# PSS Generation 1 Upgrade

*Greg Markovich*

*12/3/07*

- APS review (RSPPC, BSDRSC and Division Mgmt) held 11/29/2007

DIW flow indicator transmitters into PSS PLCs analog inputs for PSS critical beamline cooling flow  
UPGRADE SYSTEM (6)

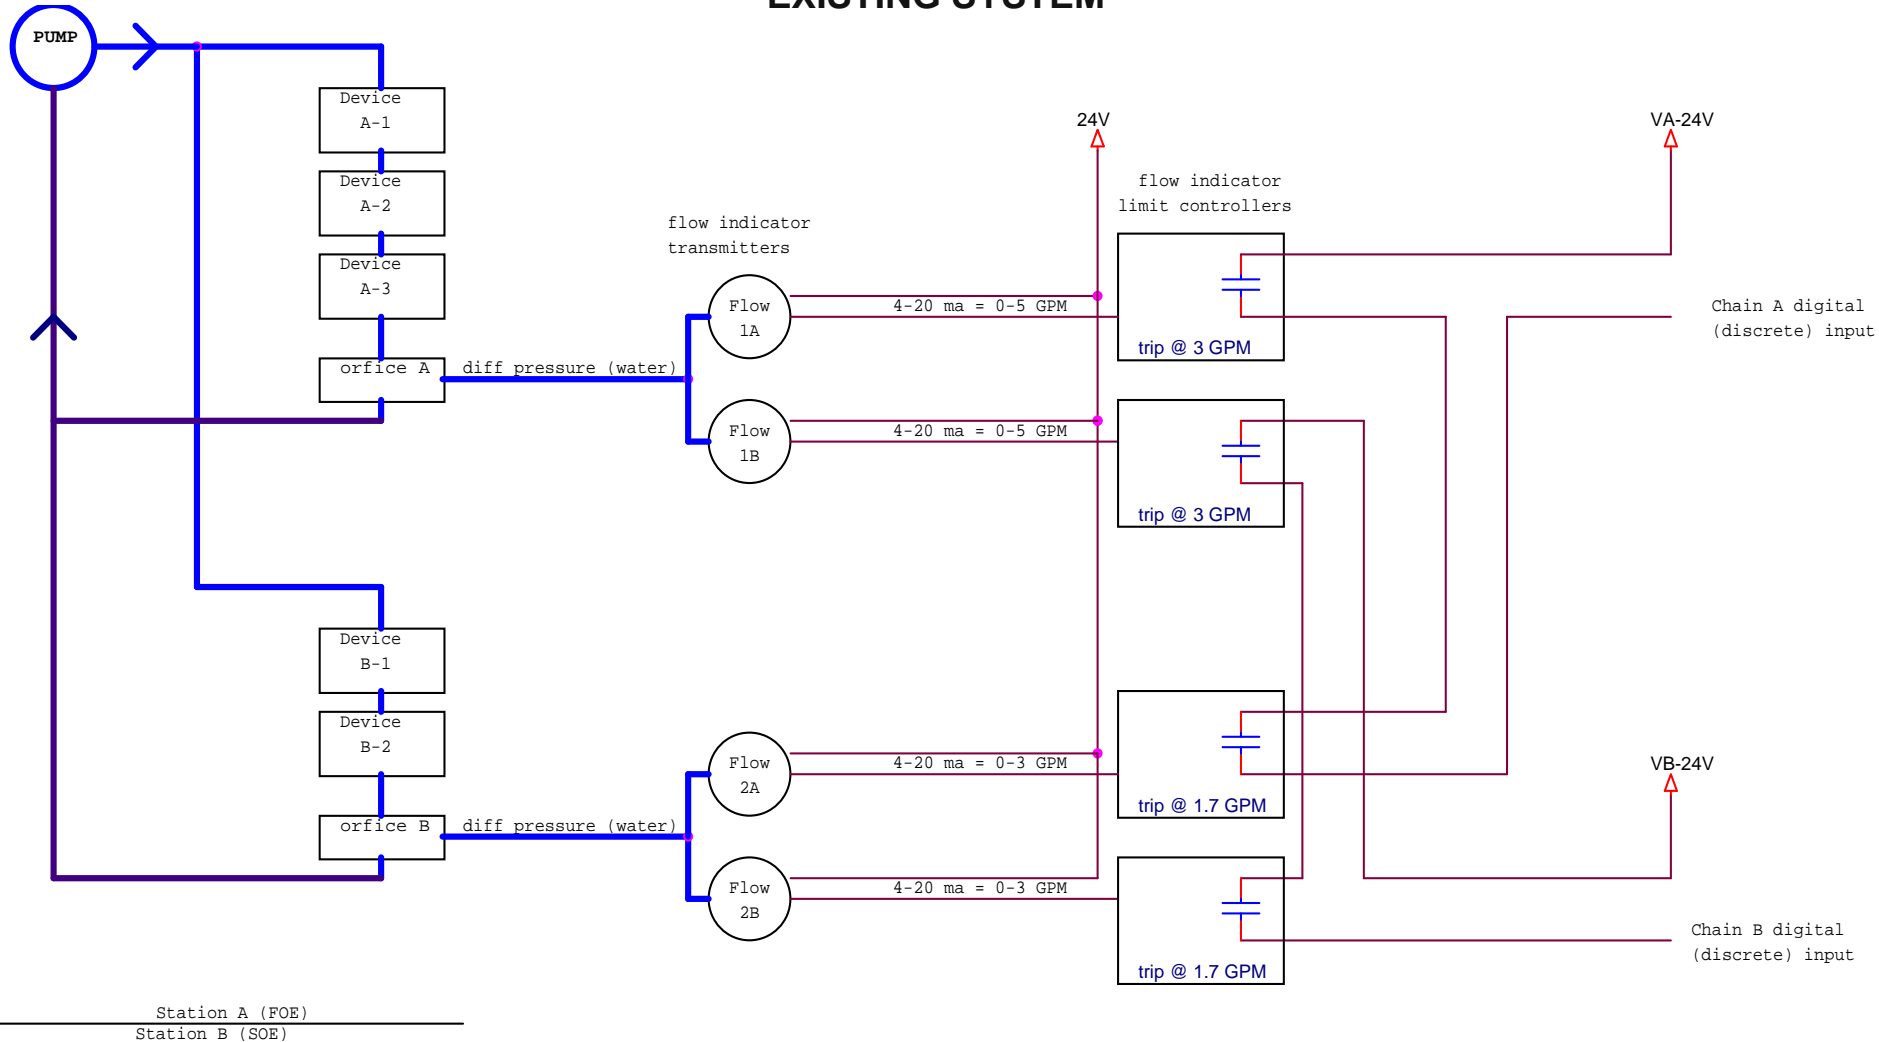
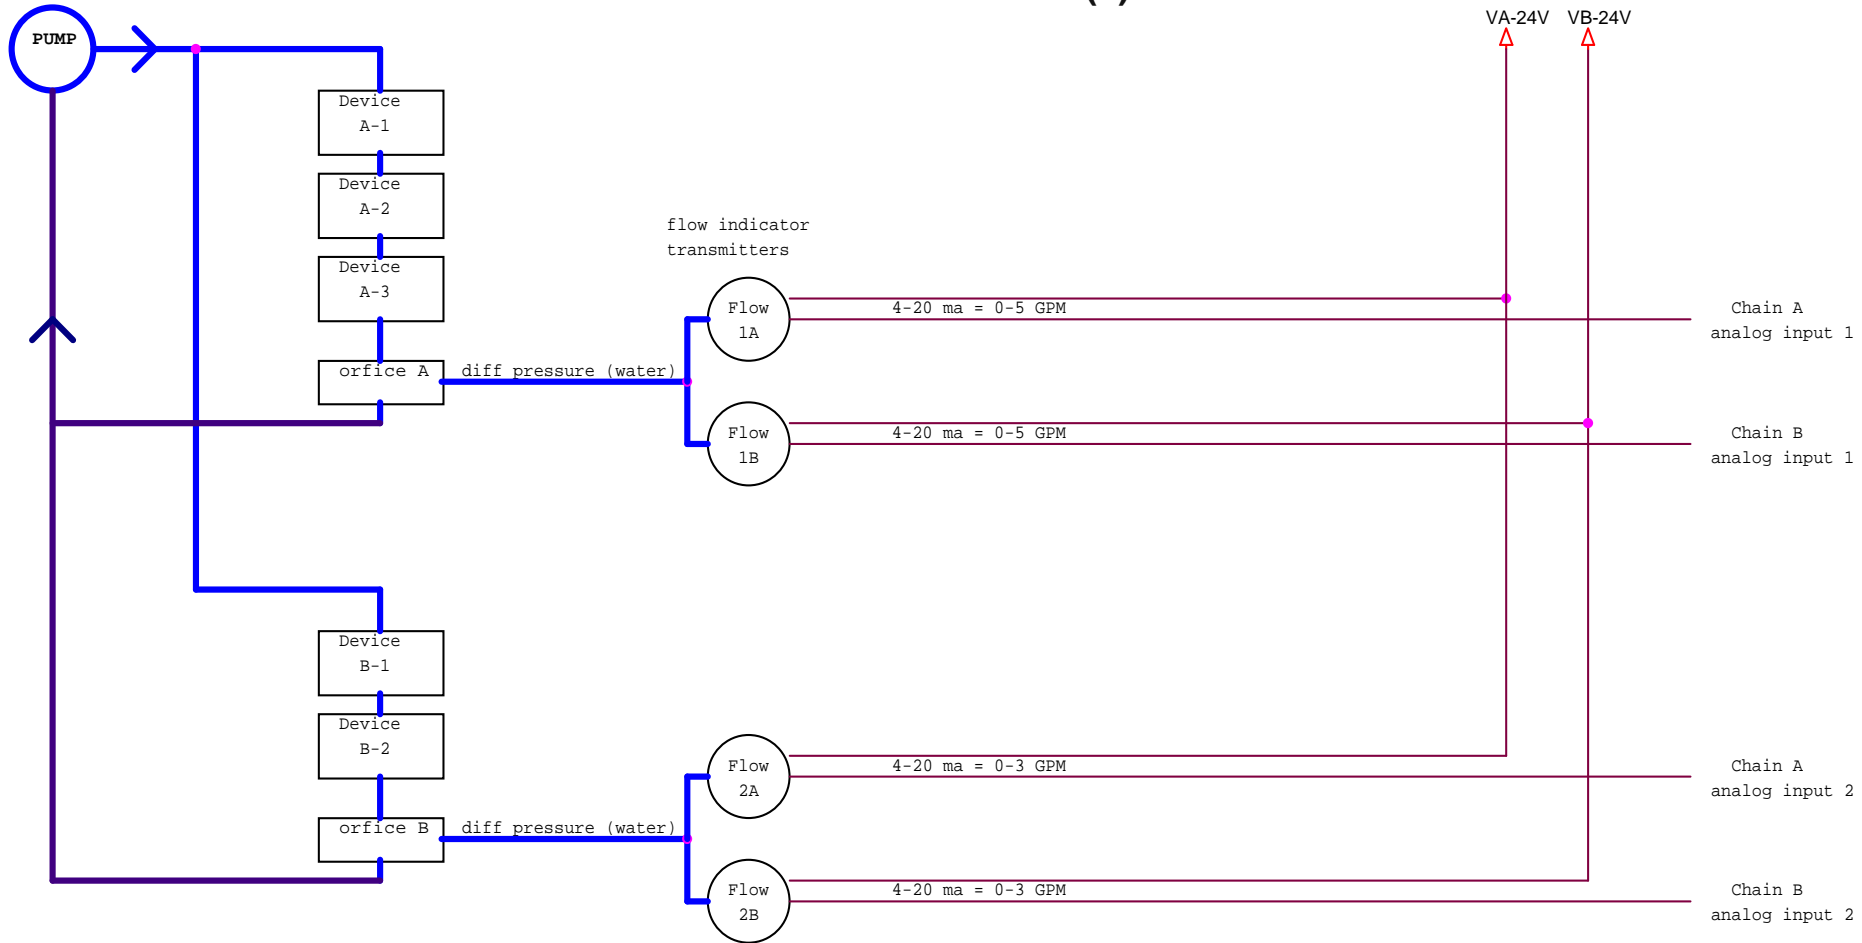
DIW flow indicator limit controllers (i.e. Love Controllers) for PSS critical beamline cooling flow  
**EXISTING SYSTEM**

- **With the addition of Analog modules to replace the “Love” controllers (6)**
  - **Additional programming is required to initialize, and set the scaling and low-flow trip points for each analog channel**
  - **Additional module error checking will be programmed into each ESD PLC**
  - **A method to change the trip points with portable HMI is being developed (this method will not require PLC code validation process following the change)**
  - **The validation process will need to check both the functionality and the scaling of each channel**

## APS ENABLE Key operation change (16)

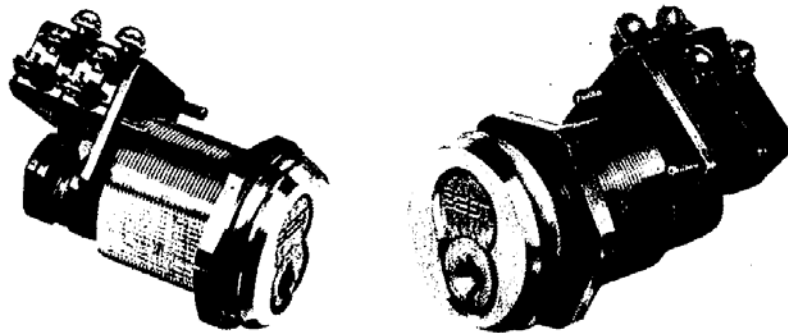
### Key & switch positions

Key pos. 1– Swt. pos. 1

Key pos. 2– Swt. pos. 2

Key pos. 1 only  
Swt. pos. 1

ORIGINAL APS ENABLE KEYSWITCH

Key pos. 1– Swt. pos. 1

Key pos. 2 Swt. pos. 2  
(360°CCW)

Key pos. 1 and 2  
Swt. pos. 1 and 2

NEW APS ENABLE KEYSWITCH

## Restructure Minor and Major Faults to Faults, Trips & Warnings (3)

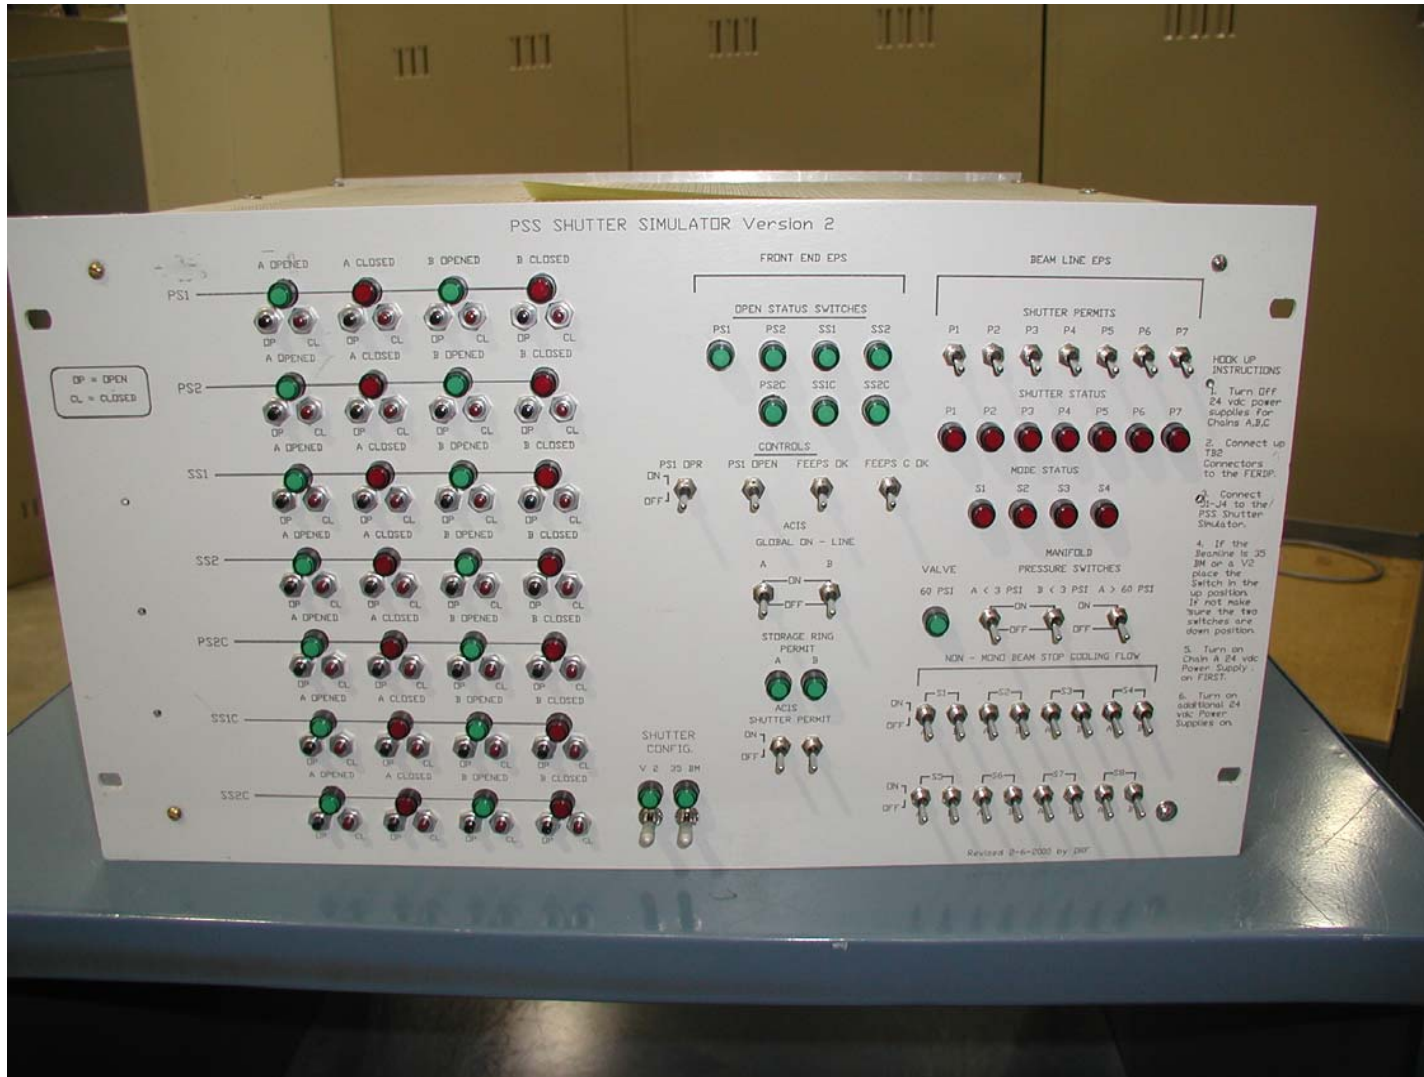
Original System Panel

New System Panel

- The SI group internal review process resulted in an analysis of the current fault structure (3)
  - Currently, all system responses are called faults and are grouped based on their effect
    - Major – remove the storage ring permit to ACIS
    - Serious – remove permits to all shutters and lock all station doors
    - Minor – remove permits to all shutters
  - This makes no differentiation between when the system is doing what it is designed to do and when it has detected an internal problem (i.e. hardware failure)

- The new system responses will be classified by their cause
  - Trip – System has responded as expected to an attempt to breach the safety envelope
    - e.g. Door opened while beam active
  - Fault – System has detected an internal inconsistency that may cause the PSS to be unable to perform in its required safety function (e.g. hardware fault)
    - e.g. Shutter switches show both opened and closed at the same time
  - Warning – Non Safety related issue
    - e.g. DIW flow below set point while station not APS Enabled
- This has no effect on the safety of the system, but helps to identify when the system needs repair, as opposed to an investigation of a possible attempt to breach the safety envelope

Beamstop cooling flows S1-S8 become ACIS Trip tests, WDT inhibits, Cross Trip inhibits & Output disable (8, 9, 13)

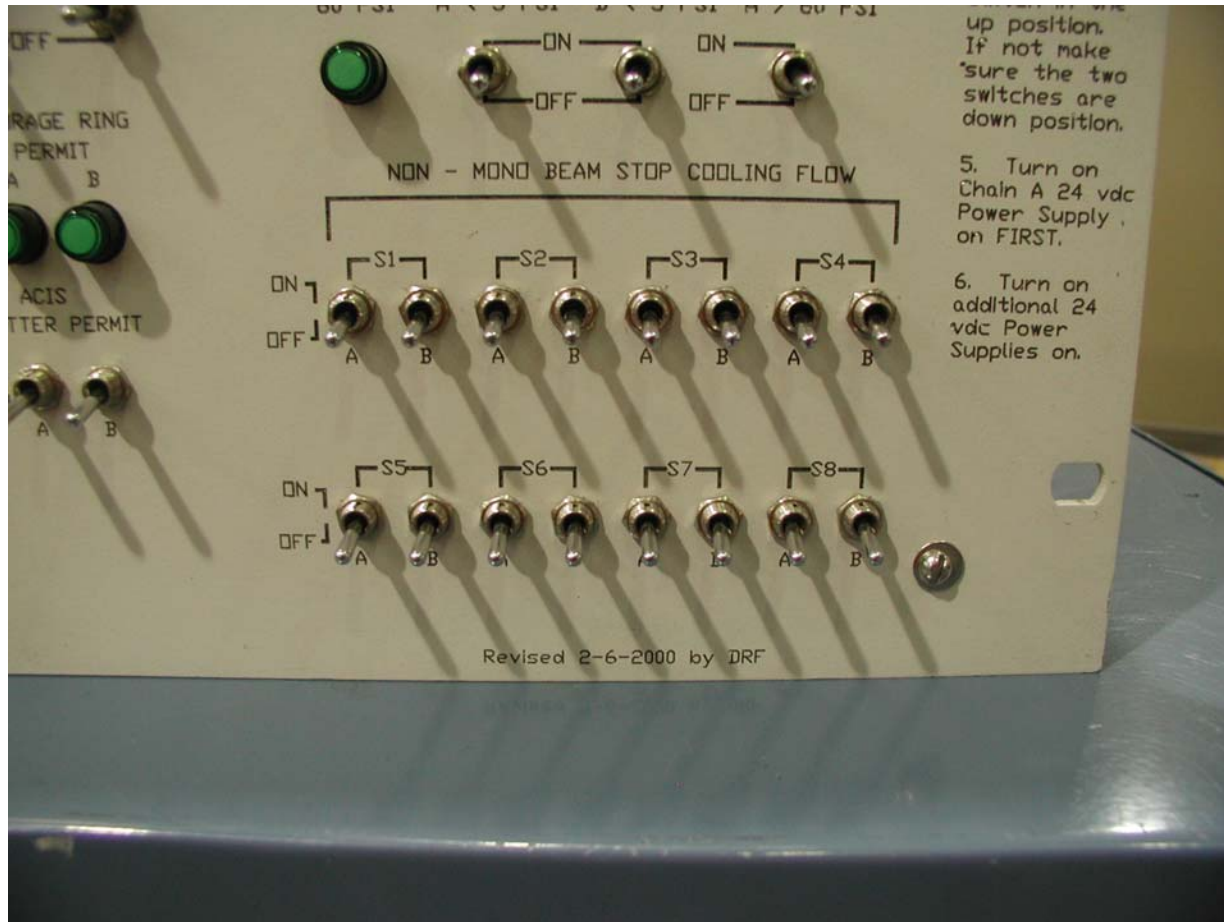
No hardware changes, only reallocation of existing signals

## What is the Output Disable input from the PSS Shutter Simulator?

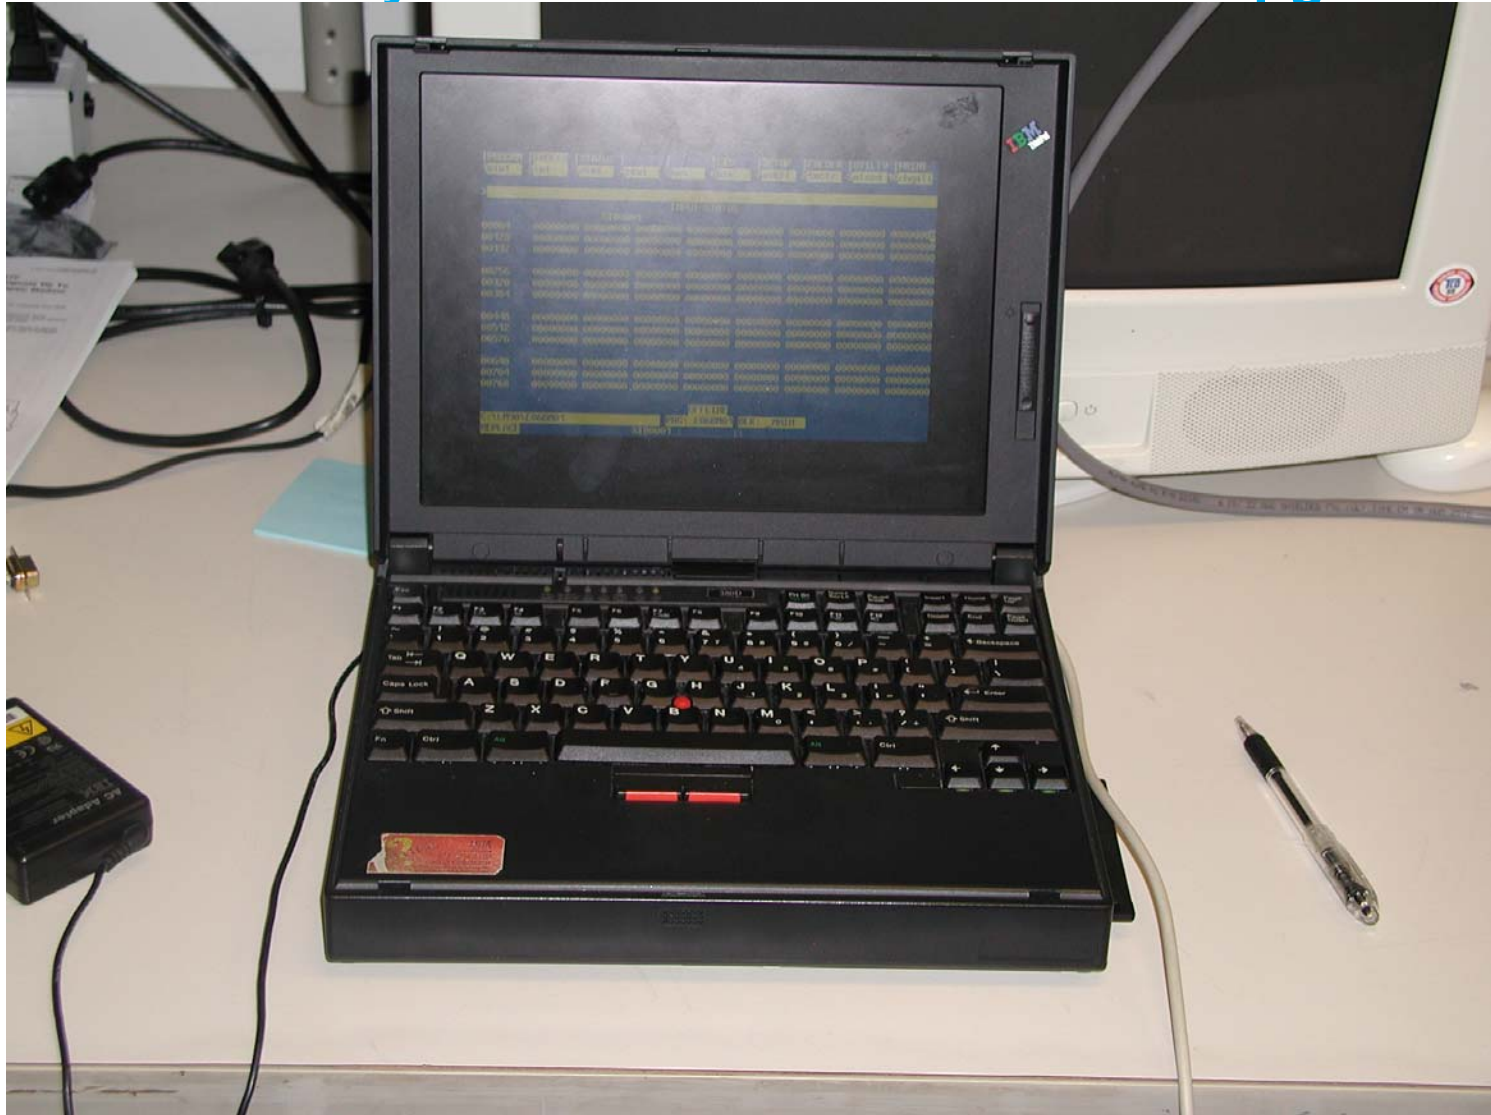
- To leave the ESD PLC code running, but stop the outputs from being turned ON, only when this test signal called “outputs disable” is present.
- This allows an temporary external HMI the ability to turn ON and OFF any PLC output to test the field wiring from that PLC module to the field device (e.g. Strobe Light or Shutter Solenoid).
- PLC input field wiring can be tested this way as well, by actuating the field device and watching the HMI indicate which PLC input changed.
- All this is done today by connecting a laptop to the ESD PLC and using the PLC vendors proprietary software development programs (some DOS and some Windows based) to monitor inputs and force outputs.
